23 Gloucester Crescent

*Heritage Impact Assessment of
Proposed Amendments to LB 2020/4735/L*

May 2021

This supporting statement forms part of a Listed Building Application seeking minor amendments to approval ref. 2020/4735/L (dated 27.01.2021) and is accompanied by the following documents:

Fig. 10 The Morton Partnership: design for steel bearing plates to replace decayed timber into existing masonry wall.

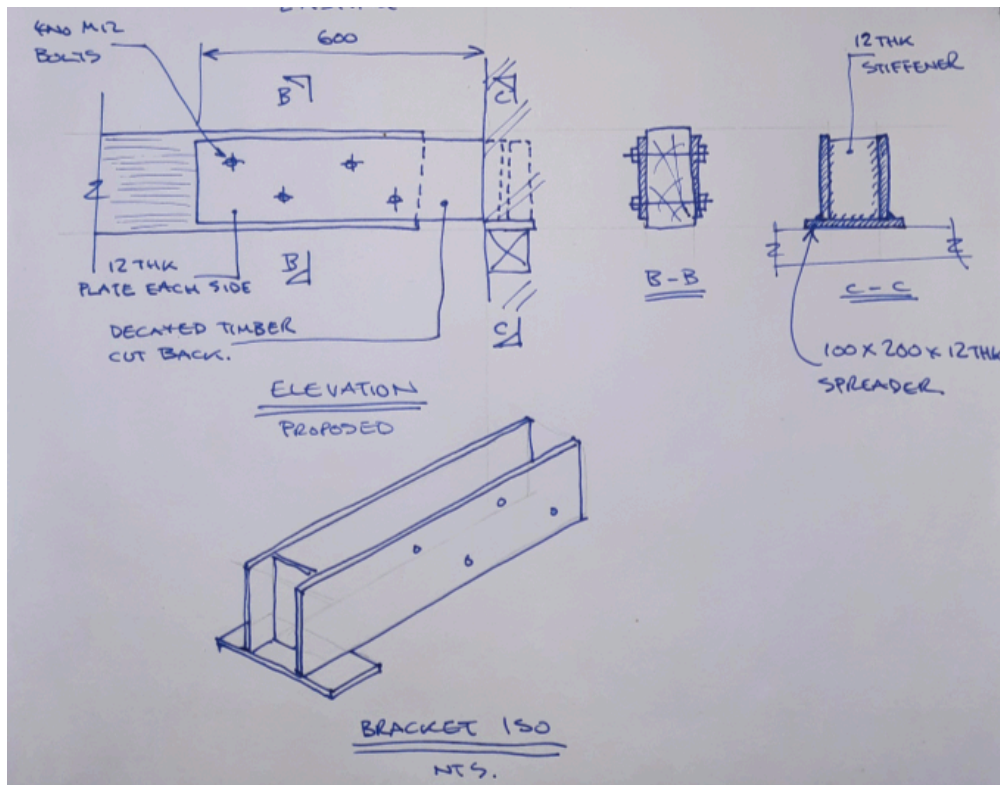
The presumption is the retention of significant original fabric wherever practical. As such the use of steel bearing plates specified by a conservation-accredited structural engineer forms part of the application, using 195 x 10mm plates to create a replacement bearing as per fig. 10. This proposal results in the valley beam being retained in situ in its existing state with a structural bearing reinstated and the load of the roof shared to the purlins.

Fig. 13 The Morton Partnership: design for steel bracket for the reinstated purlins

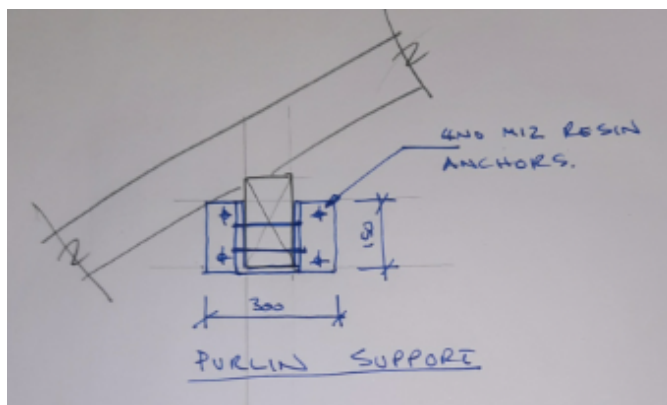
The reinstatement of the purlins cut through during the terrace installation in 1969 forms part of the consented works to the original roof. These purlins will be connected to the masonry walls using steel supporting brackets (fig. 13) as the original purlins were not bearing into the masonry walls, so no ledge or pocket is available to give support and padstones would otherwise need to be cut into the walls which is considered to be a greater intervention. It is important to gain bearing at either end of the purlins to alleviate loading of the damaged valley beam. These brackets will not be visible, with lime plaster covering the plates.

Fig. 14 The Morton Partnership: ridge beam stiffening splints

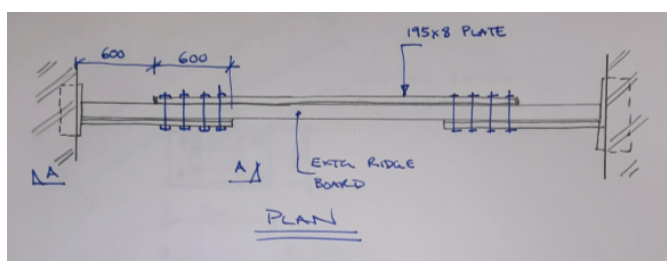
Retaining the valley beam in situ without strengthening requires the two ridge beams to be provided with additional stiffening. The plan view of the ridge beam stiffening shows the use of three steel 'splints' per ridge, again the original ridges have no bearing onto the wall, rather they provide a connection from pitch to pitch and effectively pass the majority of the roof weight onto the valley beam, which as already noted is compromised (Figs 14, 15). The steel bearing plate requires only a horizontal mortar joint to be opened up for the lateral plate to slide in, allowing the bricks to remain undisturbed.
